Appl. No. 10/506,996
Amdt. Dated Jan. 31, 2006
Reply to Office Action of Nov. 17, 2005

Amendments to the Drawings:

REMARKS/ARGUMENTS

FIG.4

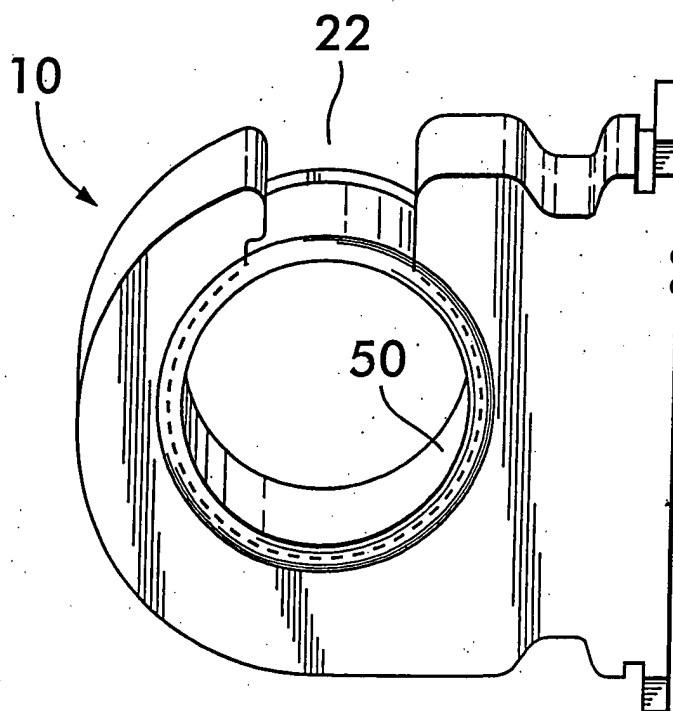
The attached sheet of drawing includes changes to Fig. 4. This sheet, which includes Figs. 4-5, replaces the original sheet including Figs. 4-5. In Fig. 4, element 40 has been re-numbered as element 41.

The Applicants have amended their drawings so that numeral (40) shown in Figure 4 has been changed to (41). Accordingly, the specification has also been amended so that now “wire bundle” is used to designate (40) and “insert” is used to designate (41). The Abstract has been corrected to remove the term “means.” The Applicants have amended their claims to more clearly define what is considered the invention. The indefinite phrase “attachment means” has been removed from the claims and reference of dependent claims to either the “fastener” or the “insert” which lacked antecedent basis have been deleted. Claim 7 has been amended to define the flap as being inwardly pivotable and located within the hook between the jaws. The Applicants have noted the re-numbering of claims due to the previous cancellation of claim 5. Support for these amendments is found in various places throughout Applicants’ specification. No new matter has been added.
